Problem Report   **Report Number: 4**

Project Name: TeraPixel APS for CALICE   (**v1.1**)

Item: Injection from DEBUG_HIT_OUT onto DEBUG_RSTVAL1

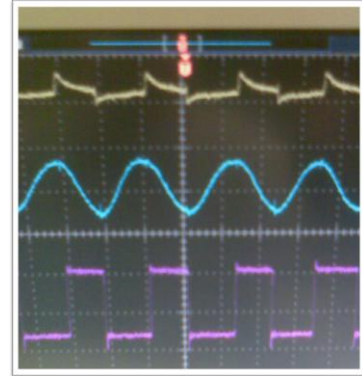
An injection of signal from the comparator to the shaper input signal in the test pixel is observed during analog test pixel investigations

A dependence on VDD1V8dig is seen in the magnitude of the injected signal on DEBUG_RSTVAL1 (yellow) and no effect on DEBUG_SIGVAL1 (blue)

Investigation reveals this is <u>NOT</u> occurring in the pixel, but rather occurs in the line from in-pixel source-follower (for the analog signal) and digital buffer (for the digital HIT signal)

Understanding of the problem is sufficient for operation of these test pixels.
No suggested action.
Be aware if re-spun, but unlikely to reoccur as is if scaled to a larger format sensor.
